Access Compliance Report

Public Rights-of-Way

(Curb Ramps)

Intersection ID: 24302	Main Street: PRESCOTT_POND_LN	Cross Street: RATHLIN_CT	Location: S
ADA ID: F422A9F04977	Ramp Type: PerpDiag	Initial Pass/Fail: Fail	Overall Compliance: No
Severity Score: 21.25			
Codes/Mitigation Info/Possible Solution		Field Measurements/Component Compliance

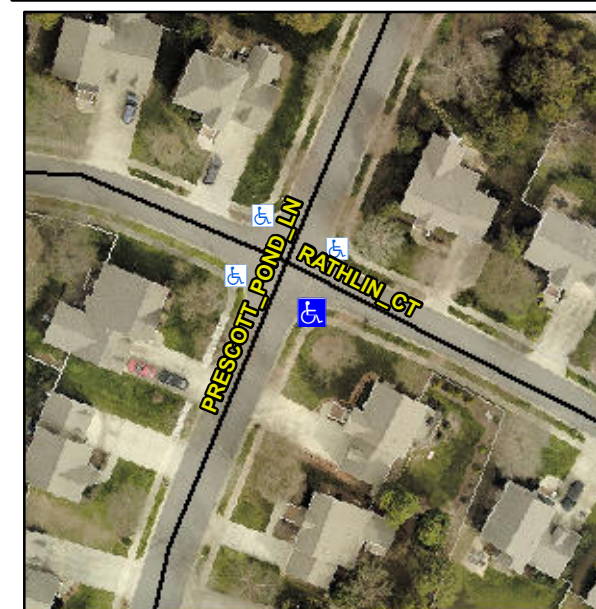
Not Found, R304.5.1, R304.2.2

Compliance	Description	Data	Compliance	Description	Data
N/A	Ramp Length (in)	47.0	No	Ramp Slope (%)	11.6
No	Ramp Width (in)	47.5	Yes	Ramp XSlope (%)	0.1
N/A	Flare Type LT	N/A	N/A	Flare Type RT	N/A
N/A	Flare Slope LT (%)	N/A	N/A	Flare Slope RT (%)	N/A
N/A	Flare Traversable LT?	N/A	N/A	Flare Traversable RT?	N/A
N/A	Landing Length (in)	N/A	N/A	DWS Provided?	N/A
N/A	Landing Width (in)	N/A	N/A	DWS Contrast?	N/A
N/A	Landing Slope (%)	N/A	N/A	DWS Length (in)	N/A
N/A	Landing X Slope (%)	N/A	N/A	DWS Full Width?	N/A
N/A	Landing Curb? (Y/N)	N/A	N/A	DWS Offset (in)	N/A
N/A	Shared Landing?	N/A			
N/A	Gutter Ponding?	N/A	N/A	Gutter Slope (%)	N/A
N/A	Gutter Lip Ht (in)	N/A	N/A	Gutter X Slope (%)	N/A
N/A	Painted X Walk1?	No	N/A	Painted X Walk2?	No
	X Walk 1 Direction	To NE		X Walk 2 Direction	To NW
N/A	X Walk 1 Width (in)	N/A	N/A	X Walk 2 Width (in)	N/A
	X Walk 1 Slope (%)	0.2		X Walk 2 Slope (%)	0.8
	X Walk 1 X Slope (%)	1.8		X Walk 2 X Slope (%)	0.7

Remove & Replace Curb Ramp With Two New Directional Ramps or Equivalent.
